In an Advisory Action mailed June 18, 2001, in the parent application (Serial No. 09/124,291), Examiner Olsen stated that “. . . claim 1 recites ‘reducing the deposition. . .’ and the preamble of claim 17 recites ‘reducing a deposit’ but it is not clear what is to be used as the basis for comparison in determining that the amount of deposit is actually reduced. In fact, phrases such as, reducing the deposits, can be interpreted in a number of different ways. To some, this phrase might suggest that a chemical reaction has brought about the lowering of the oxidation state of the material comprising the deposit, in addition, the phrase ‘reducing a deposit of materials. . .’ could suggest that the claims include a chamber cleaning method.” It is applicants’ opinion that no one skilled in the art to which the invention belongs would interpret the phrase “reducing the deposition” or “reducing a deposit” to mean that the oxidation state of the material comprising the deposit has been lowered, since no mention of the oxidation state of the depositing materials is found anywhere within applicants’ originally filed specification. Further, there is nothing in applicants’ specification that wo

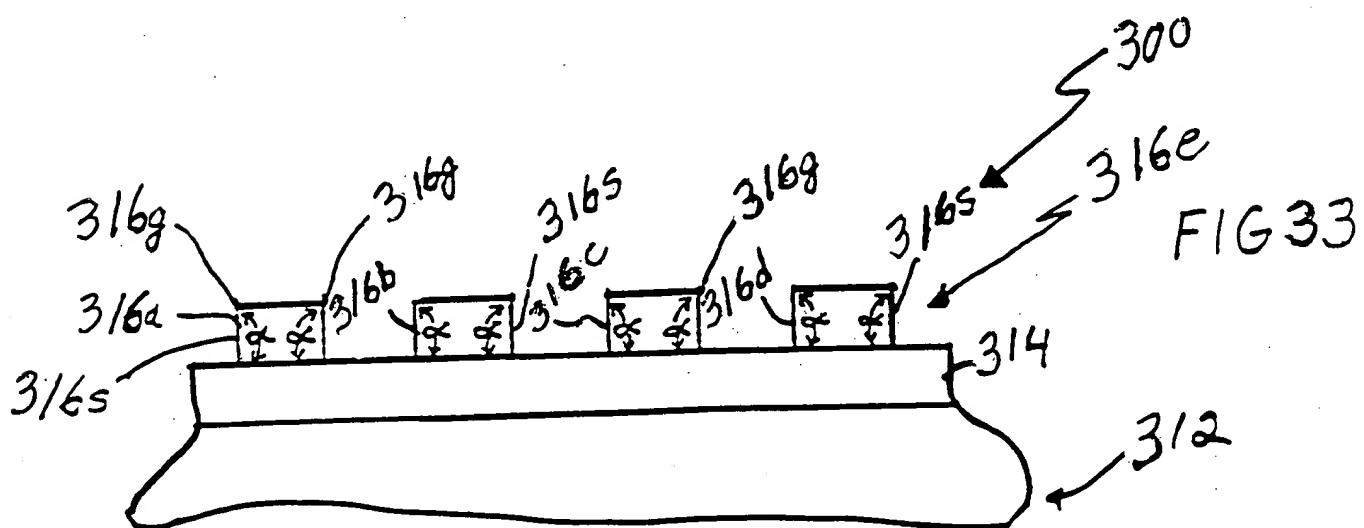
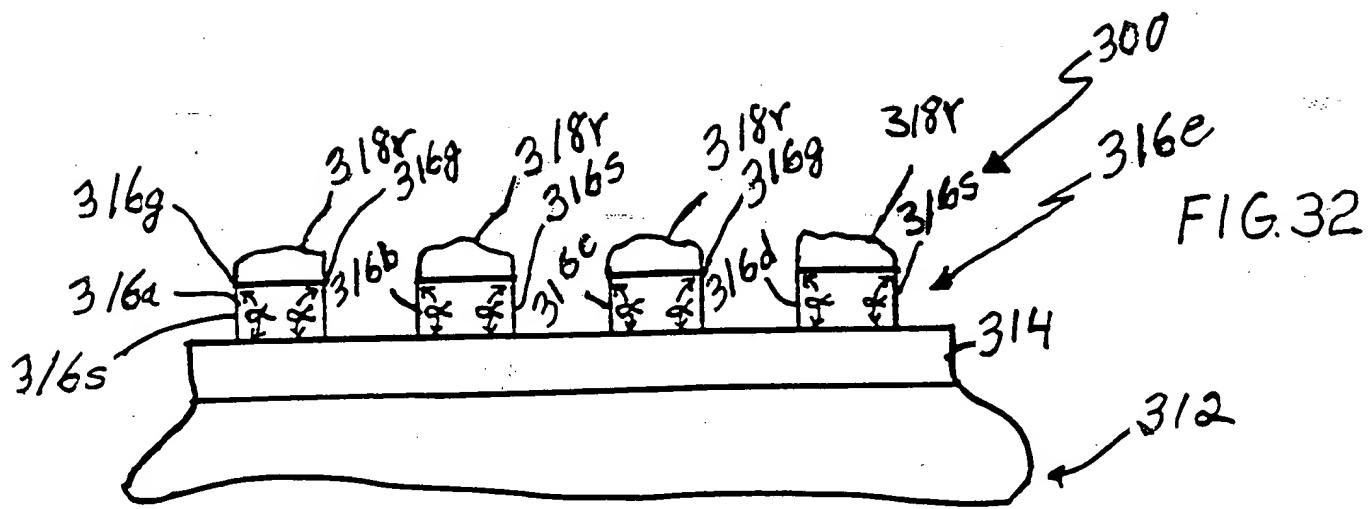
Enclosed are two sheets of marked-up, amended drawings. In the originally submitted drawings, reference characters 318r and 18r were both used to designate the residual mask layer in Figure 32, and reference characters 316s and 16s were both used to designate the Pt sidewall in Figures 32 and 34. In the amended drawings, Figure 32 has been corrected so that only reference characters 318r and 316s have been used to designate the residual mask layer and Pt sidewall, respectively. Figure 34 has been similarly corrected. Also enclosed are 31 sheets of proposed formal drawings to replace the originally filed informal drawings.
